# Access Compliance Report

## Public Rights-of-Way

Intersection ID: 12611	Main Street: S_CHURCH_ST	Cross Street: W_STONEWALL_ST	Location: N
ADA ID: E4C1581F6C9F	Ramp Type: PerpDiag	Initial Pass/Fail: Pass	Overall Compliance: No
Severity Score: 22.75			
Codes/Mitigation Info/Possible Solution		Field Measurements/Component Compliance

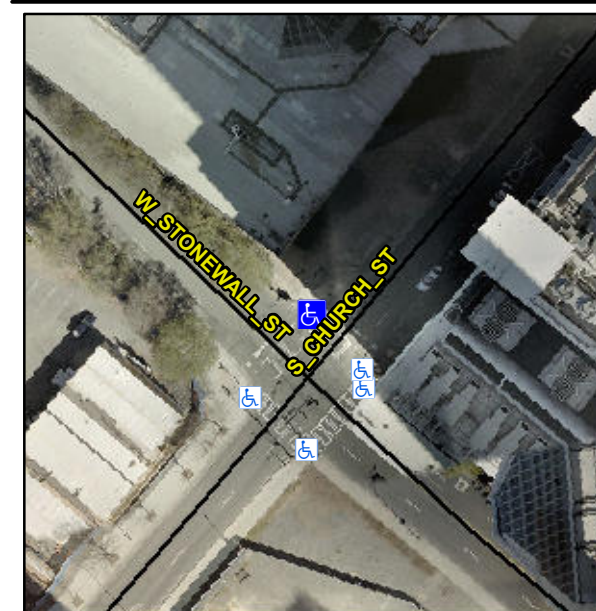
**Not Found, R304.5.3, R304.2.3, R305.2, R302.7.2, R304.5.4**

Compliance	Description	Data	Compliance	Description	Data
N/A	Ramp Length (in)	60.0	Yes	Ramp Slope (%)	6.3
Yes	Ramp Width (in)	48.0	No	Ramp XSlope (%)	3.9
N/A	Flare Type LT	Sloped	N/A	Flare Type RT	N/A
N/A	Flare Slope LT (%)	6.4	No	Flare Slope RT (%)	12.0
N/A	Flare Traversable LT?	No	N/A	Flare Traversable RT?	Yes
Yes	Landing Length (in)	60.0	Yes	DWS Provided?	Yes
Yes	Landing Width (in)	60.0	Yes	DWS Contrast?	Yes
Yes	Landing Slope (%)	0.3	Yes	DWS Length (in)	24.0
Yes	Landing X Slope (%)	0.7	Yes	DWS Full Width?	Yes
N/A	Landing Curb? (Y/N)	No	No	DWS Offset (in)	4.5
N/A	Shared Landing?	No			
Yes	Gutter Ponding?	No	No	Gutter Slope (%)	5.7
No	Gutter Lip Ht (in)	4.0	Yes	Gutter X Slope (%)	1.9
N/A	Painted X Walk1?	Yes	N/A	Painted X Walk2?	Yes
	X Walk 1 Direction	To SW		X Walk 2 Direction	To SE
N/A	X Walk 1 Width (in)	118.0	N/A	X Walk 2 Width (in)	111.0
	X Walk 1 Slope (%)	1.6		X Walk 2 Slope (%)	5.3
	X Walk 1 X Slope (%)	2.5		X Walk 2 X Slope (%)	2.1

Yes	Ramp inside XWalk1?	Yes	Yes	Ramp inside XWalk2?	Yes
	Road Slope (%)	0.2	N/A	Clear Space?	Yes
	Road X Slope (%)	4.8	Yes	Clear Space to XWalk (in)	90.0
Yes	Any Obstructions?	No	Yes	Storm Grate/Utility Hazard?	No
	Obstruction Type			Storm Grate/Utility Type	
		N/A			N/A
			Yes	Surface Condition? (G/P)	Good

**Remove & Replace Curb Ramp With Two New Directional Ramps or Equivalent. Remove & Replace Gutter.**
